#### SITE INSTRUCTION

PROJECT: HAMPTON MANOR

PROJECT NO: 14-016

SITE INSTRUCTION: E-13

SINGLE LINE DIAGRAM

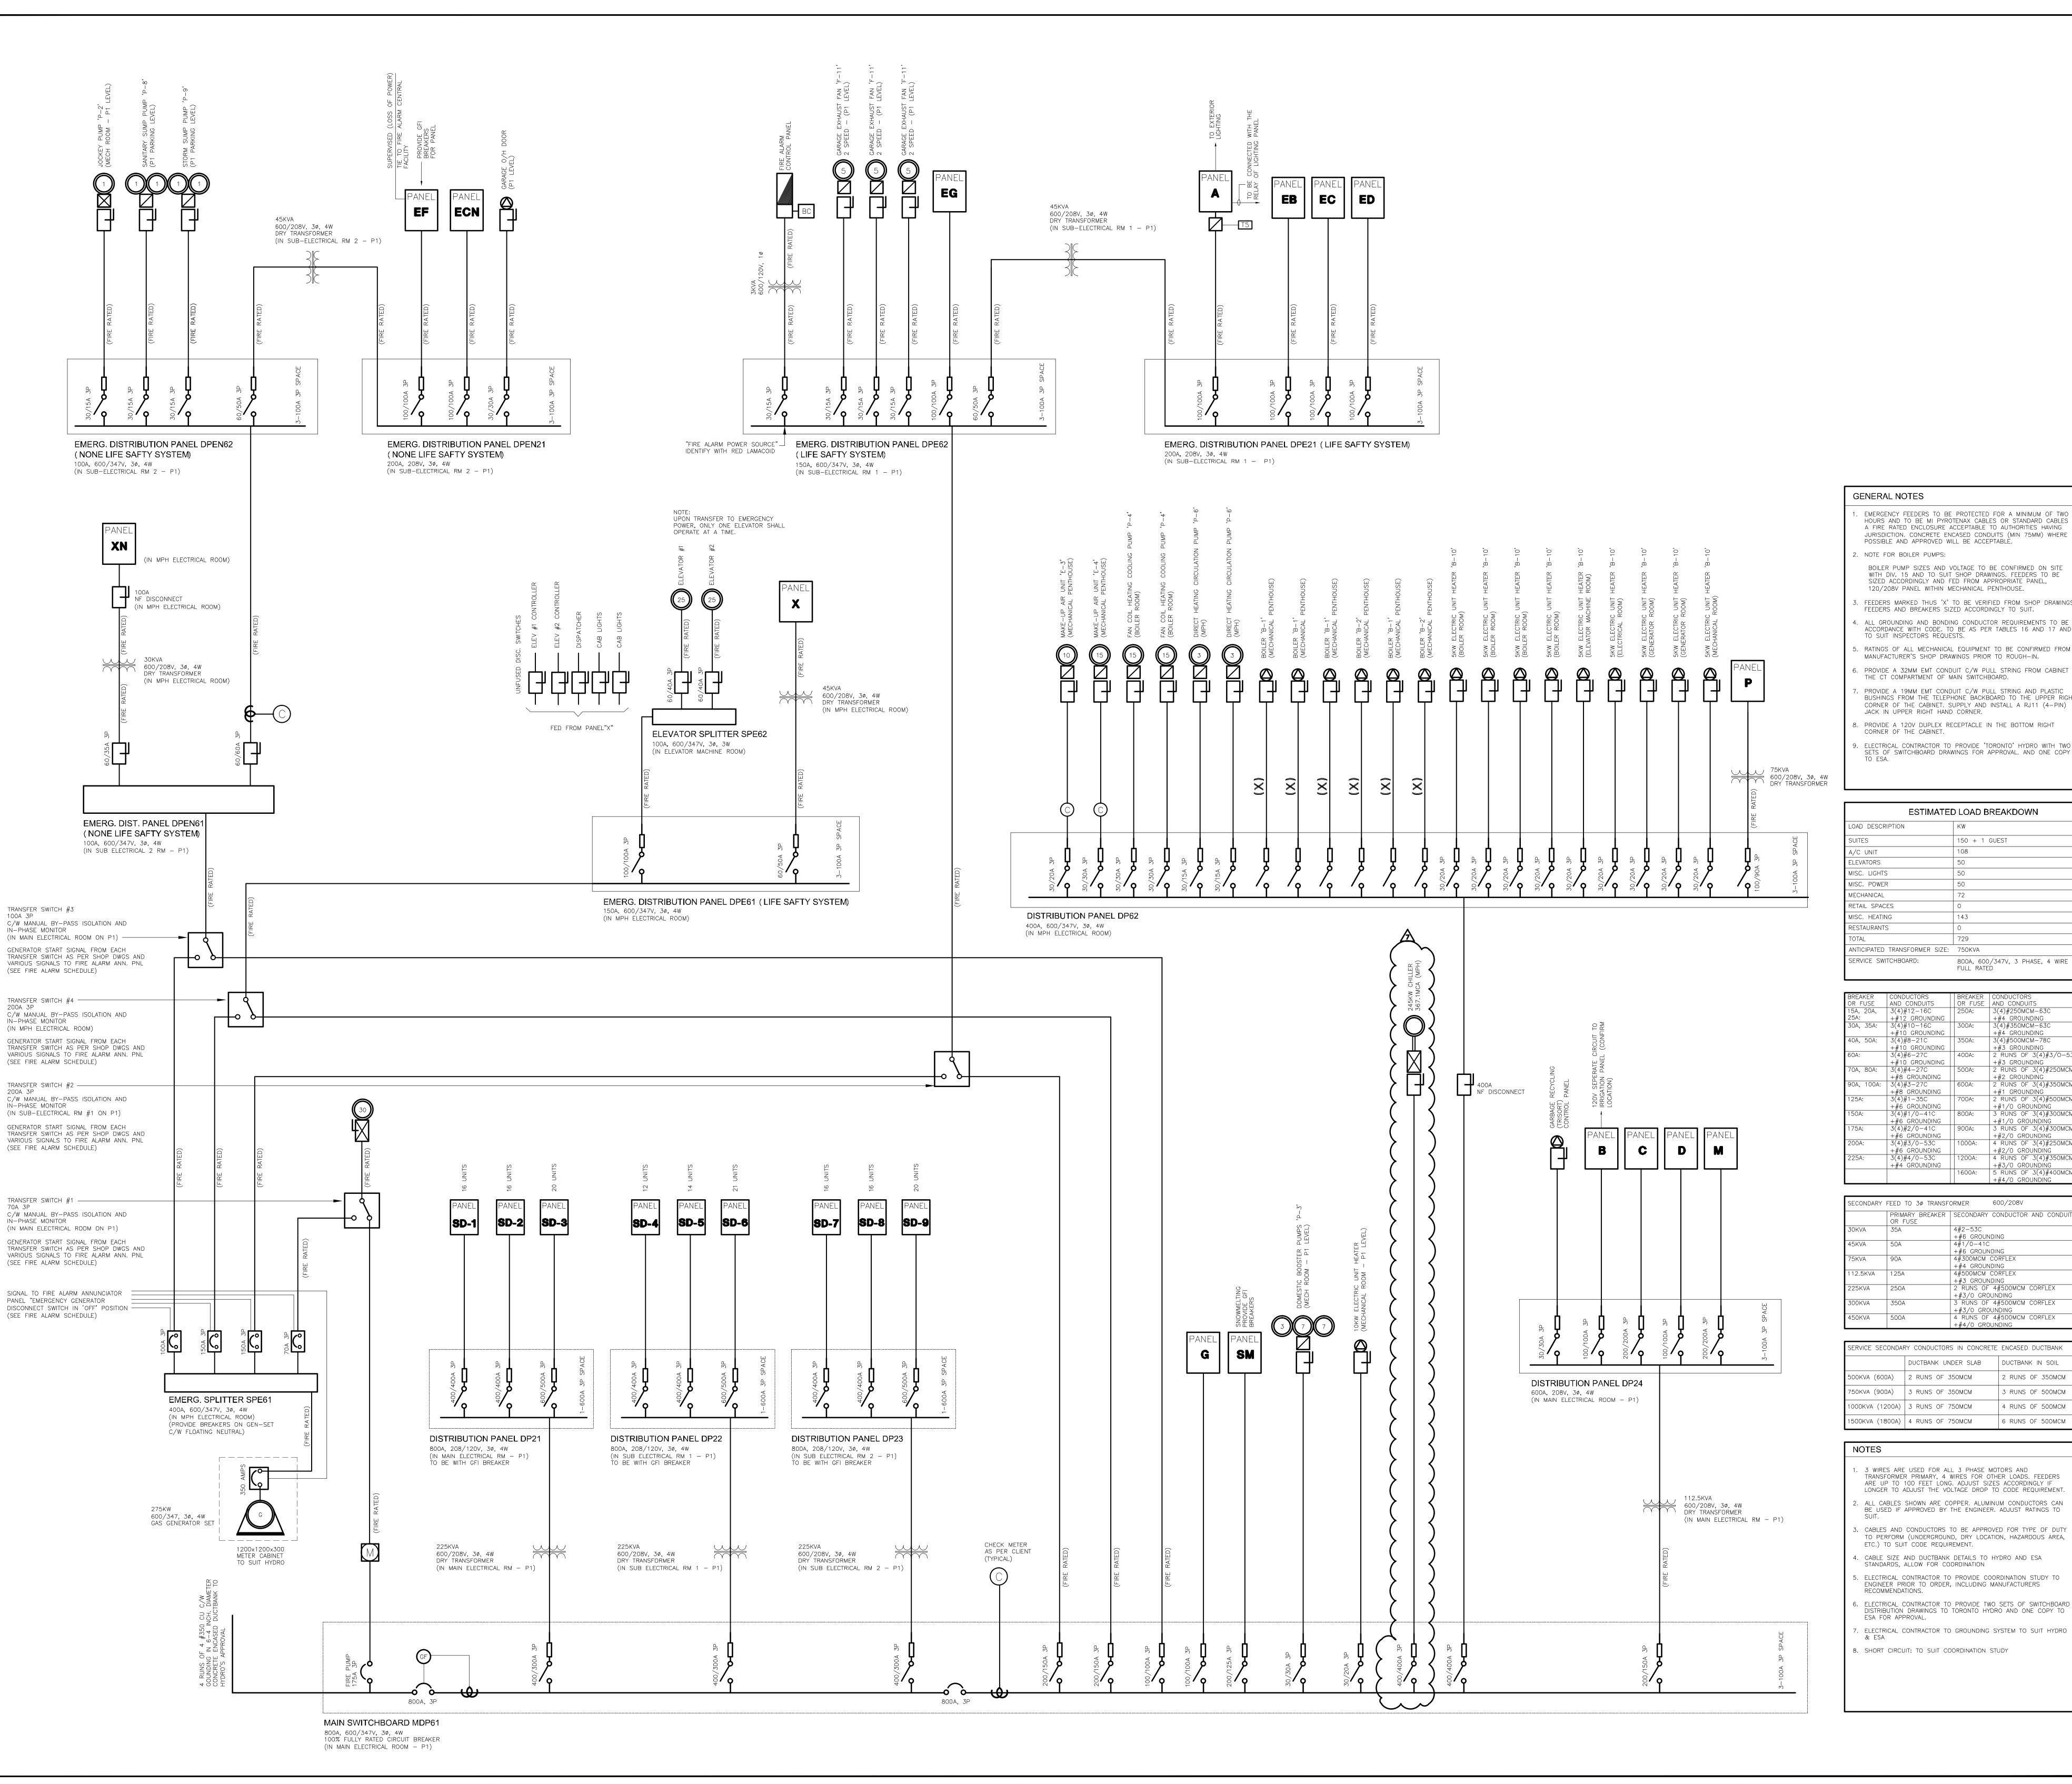
#### 4.0 Reference Drawing E-11 (Single Line Diagram) Issued

4.1 Revise:

Fuse size for chiller to be 400A to suit shop drawings.
